Access Compliance Report Public Rights-of-Way (Curb Ramps)

Main Street: CHIANTI_DR Cross Street: ST_ALBANS_DR Location: SW

ADA ID: RPRK211221120301 Ramp Type: Type 1 - Perpendicular Diagonal Initial Pass/Fail: Pass Overall Compliance: No Severity Score: 14

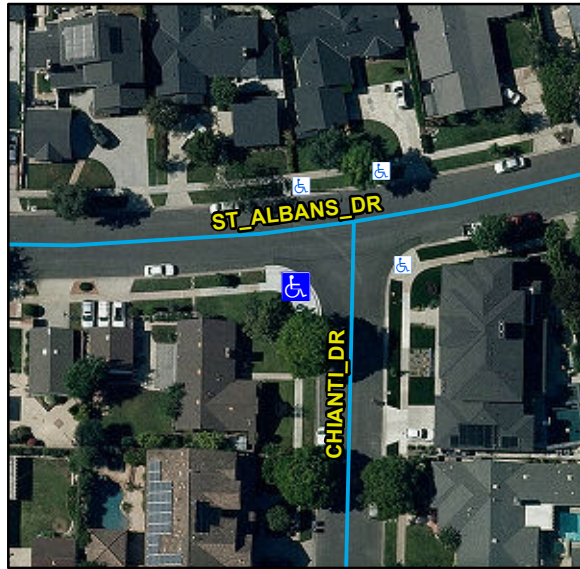
R304.2.1, R305, STD 1115

Remove & Replace Curb Ramp With Two New Directional Ramps or Equivalent.
